# UNITED STATES PATENT AND TRADEMARK OFFICE

APPLICATION NO.	FILING DATE	FIRST NAMED INVENTOR	ATTORNEY DOCKET NO.	CONFIRMATION NO.
10/674,354	10/01/2003	Nobuhiro Inoue	243412US3	3815
22850	7590	10/25/2006	EXAMINER	
C. IRVIN MCCLELLAND OBLON, SPIVAK, MCCLELLAND, MAIER & NEUSTADT, P.C. 1940 DUKE STREET ALEXANDRIA, VA 22314				LAZORCIK, JASON L
		ART UNIT		PAPER NUMBER
		1731

<b>Office Action Summary</b>	<b>Application No.</b>	<b>Applicant(s)</b>	
	10/674,354	INOUE ET AL.	
	<b>Examiner</b>	<b>Art Unit</b>	
	Jason L. Lazorcik	1731

**DETAILED ACTION**

**FIG. 6A**

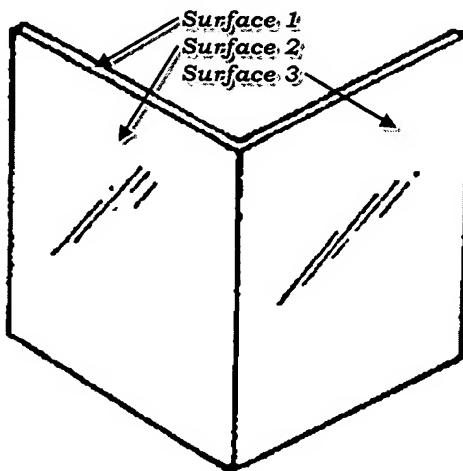
larger than 100mm. Further as clearly depicted in figure 6a, Tomozane teaches a glass sheet which includes a corner where three surfaces connect together and each surface is a flat surface.

Tomozane does not explicitly indicate the applied force needs to comply with the relationship as set forth in formula 2. It is understood from the applicants specification that controlling the "bending evaluation index" value to the range outlined in claim 1 is performed in order to avoid the formation of a wrinkle in a peripheral edge of the sheet or "the formation of several kinds of optical distortions in the glass sheet" (Specification pg 3, Lines 10-14). Tomozane clearly indicates that the applied force or applied pressure as a function of time is "***precisely controlled***" to preclude the generation of cracks or a kind of "optical distortion" at the bend area. In addition, the Tomozane process is undertaken on glass material heated to a viscosity falling within the claimed range of  $10^5$  to  $10^8$  poise. It would have therefore been obvious to one of ordinary skill

in the art at the time of the invention to control the bending time, viscosity, and applied pressure as a function of time in order to comply with the "bending evaluation index" range as claimed above in order to preclude the formation of optical distortions in a bent sheet of glass.
